## PIC18F66K80 Family Silicon Errata and Data Sheet Clarification

The PIC18F66K80 family devices that you have received conform functionally to the current Device Data Sheet (DS39977F), except for the anomalies described in this document.

**FIGURE 11-2: USING THE OPEN-DRAIN OUTPUT (USARTx SHOWN AS EXAMPLE)**

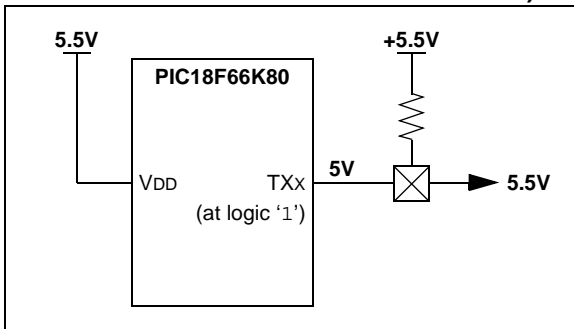
[Figure 11-2: Using the Open-Drain Output \(Usart Shown as Example\)](#) on page 173 should be as follows:

Page 173 **Section 11.1.3 'Open-Drain Outputs'** will be revised to:

The output pins for several peripherals are also equipped with a configurable, open-drain output option. **This allows the peripherals to communicate with external pull-up voltage.**

**When the open-drain option is required, the output pin must also be tied through an external pull-up resistor provided by the user.**
